# HISTORIC AND DESIGN REVIEW COMMISSION

**HDRC CASE NO:** 2021-027  
**ADDRESS:** 520 LEIGH ST  
**LEGAL DESCRIPTION:** NCB 2739 BLK LOT 4F & PT OF 5F (AKA TRACT 6)  
**ZONING:** IDZ,H  
**CITY COUNCIL DIST.:** 1  
**DISTRICT:** Lavaca Historic District  
**APPLICANT:** San Antonio San Antonio/LABOR STREET COMMONS LLC  
**OWNER:** San Antonio San Antonio/LABOR STREET COMMONS LLC  
**TYPE OF WORK:** Construction of a 2-story residential structure, site modifications  
**APPLICATION RECEIVED:** January 15, 2021  
**60-DAY REVIEW:** Not applicable due to City Council Emergency Orders  
**CASE MANAGER:** Stephanie Phillips

The applicant is requesting final approval to construct a new 2-story single family residence at the lot addressed 520 Leigh St.

A0.2 SITE PLAN  
Scale 3/32" = 1'-0"

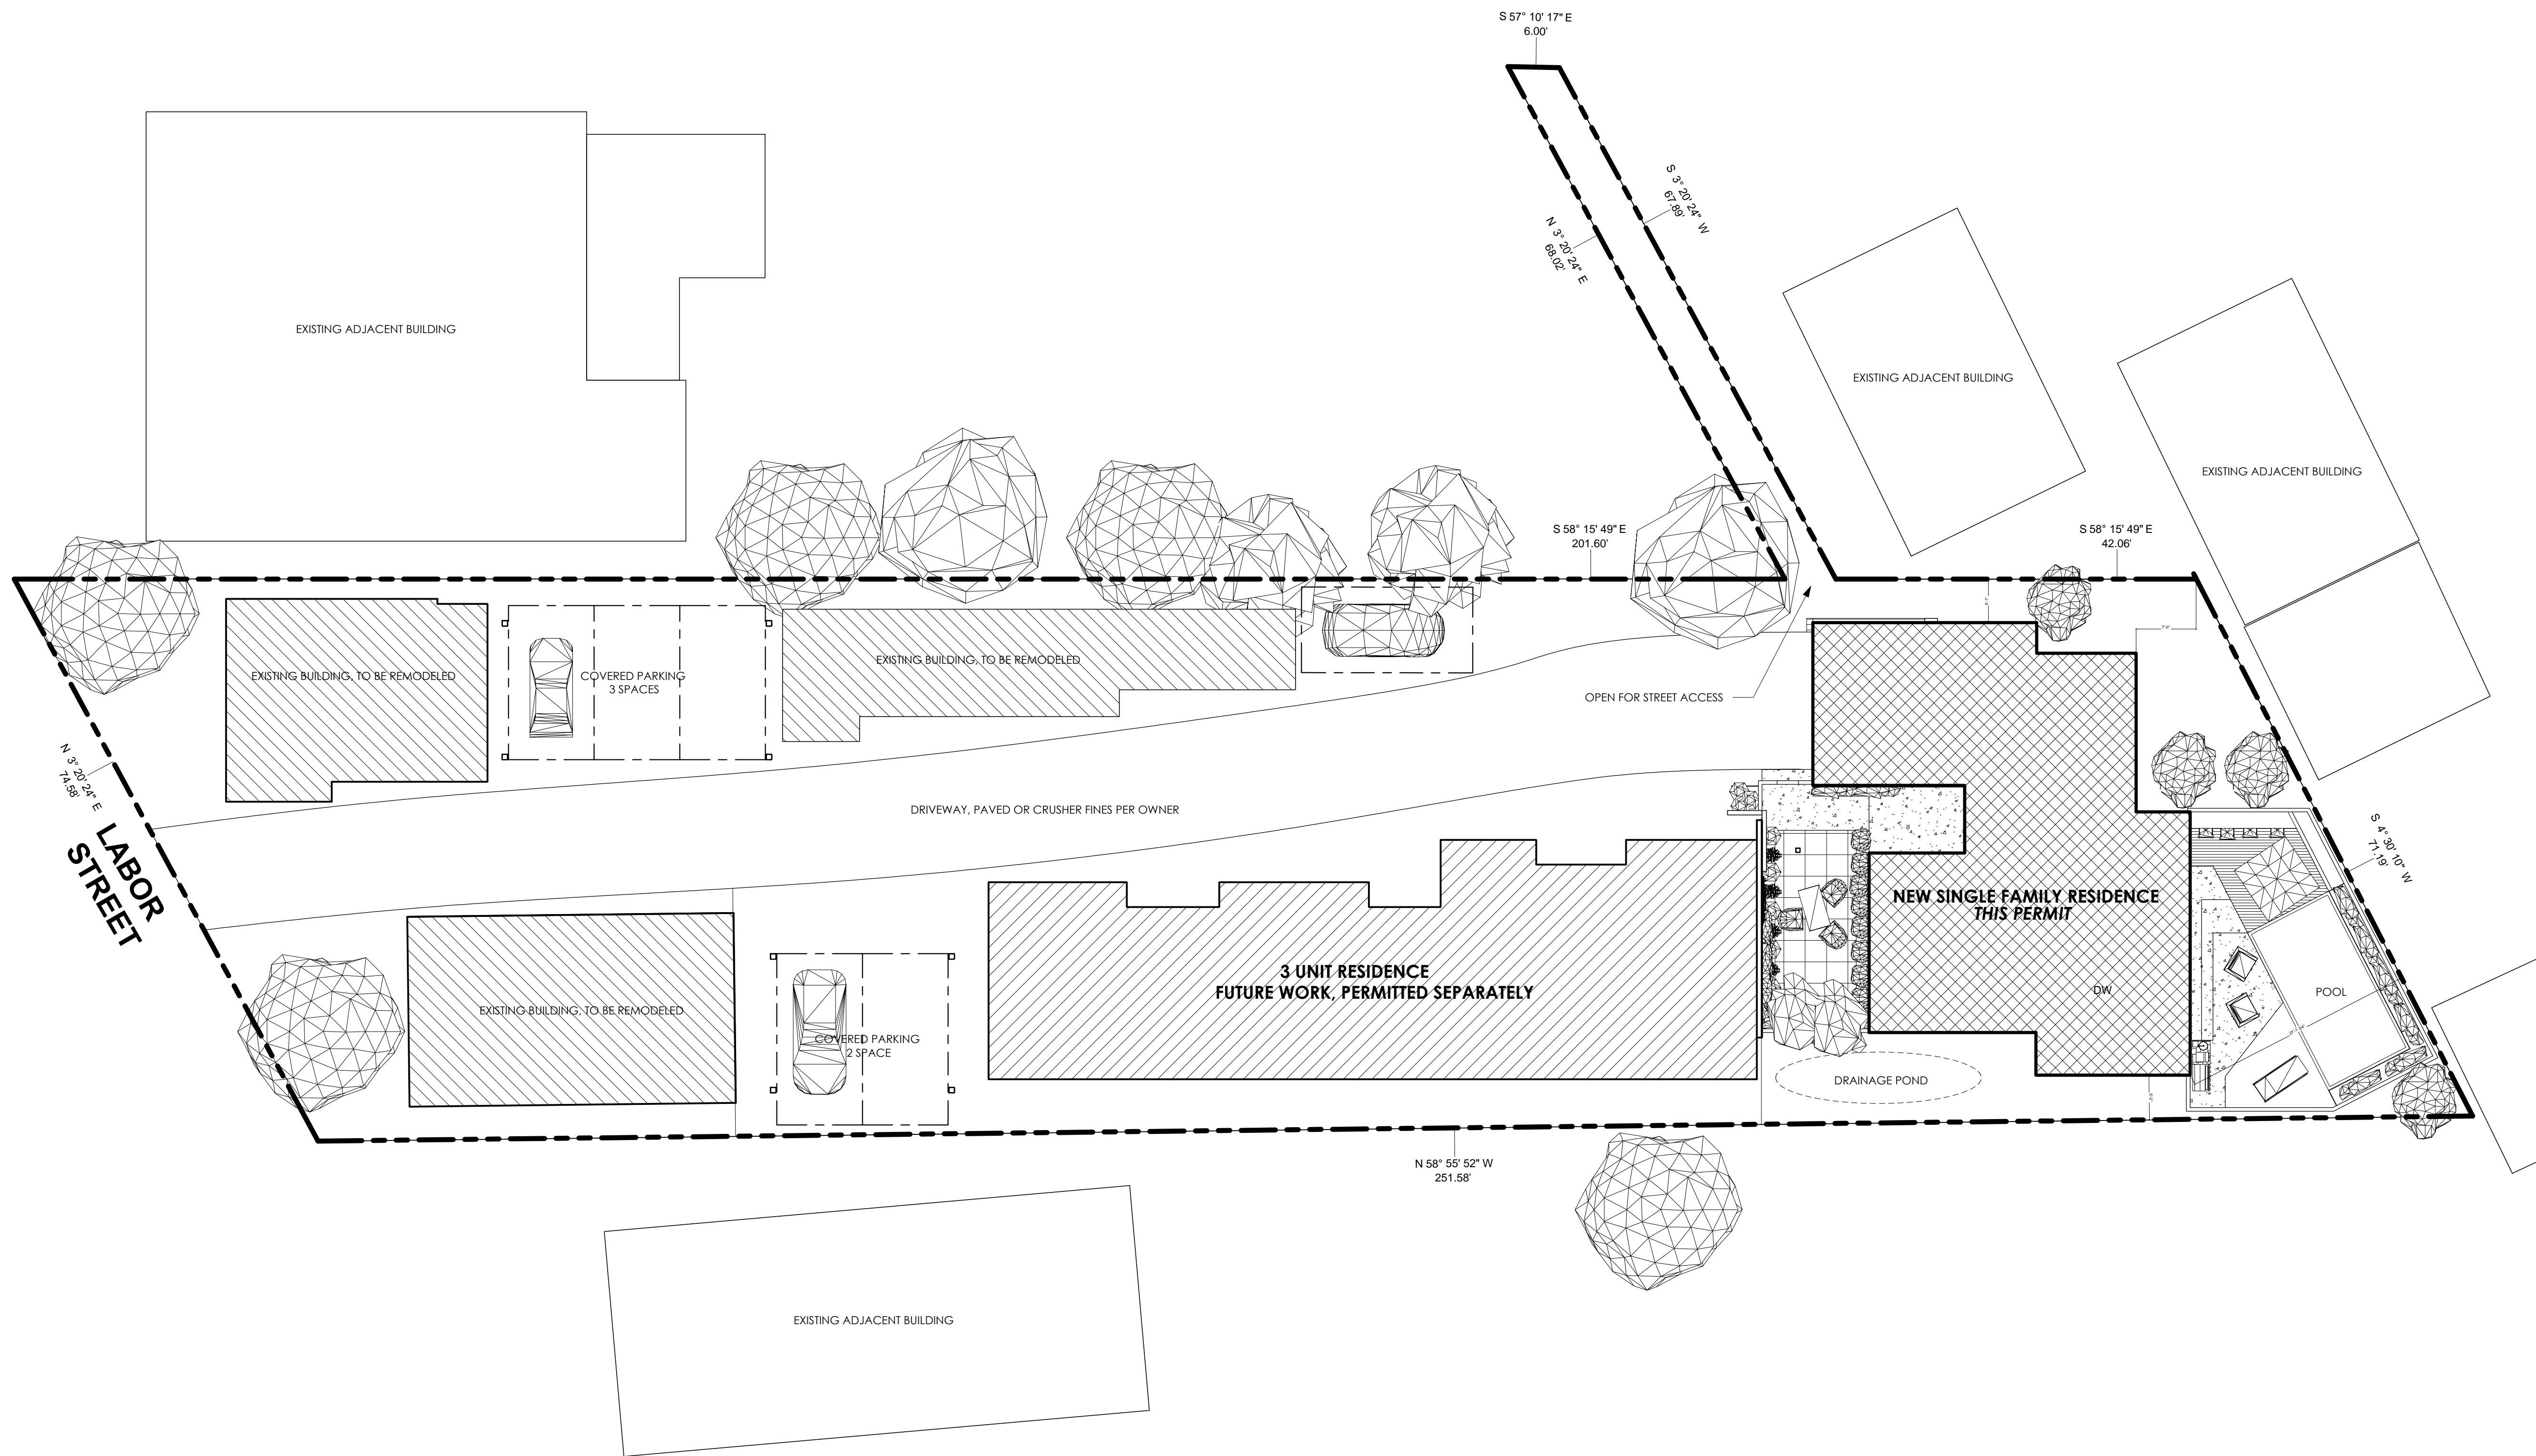
- m. LOT COVERAGE – Per the Guidelines for New Construction 2.D.i., applicants should limit the building footprint for new construction to no more than 50 percent of the total lot area, unless adjacent historic buildings establish a precedent with a greater building to lot ratio. Staff does not find the lot coverage consistent with the Guidelines.

- q. DRIVEWAY AND SITE ELEMENTS – The applicant has provided the location of walkways and driveways. Per the applicant, the proposed structure will be accessed through the center of the adjacent parcels addressed 606-608 Labor. There is not a precedent for this kind of access in the historic district, and the separate parcels creates a condition whereby a change of ownership could render the proposed rear structure inaccessible without an agreement for access.

- i. That the applicant provides a comprehensive site analysis, including photos of area structures, line-of-sight studies, perspectives from both Labor and Leigh streets, documentation indicating the heights and massing of nearby structures, and site plan that indicates the percentage of proposed lot coverage as noted in the findings.
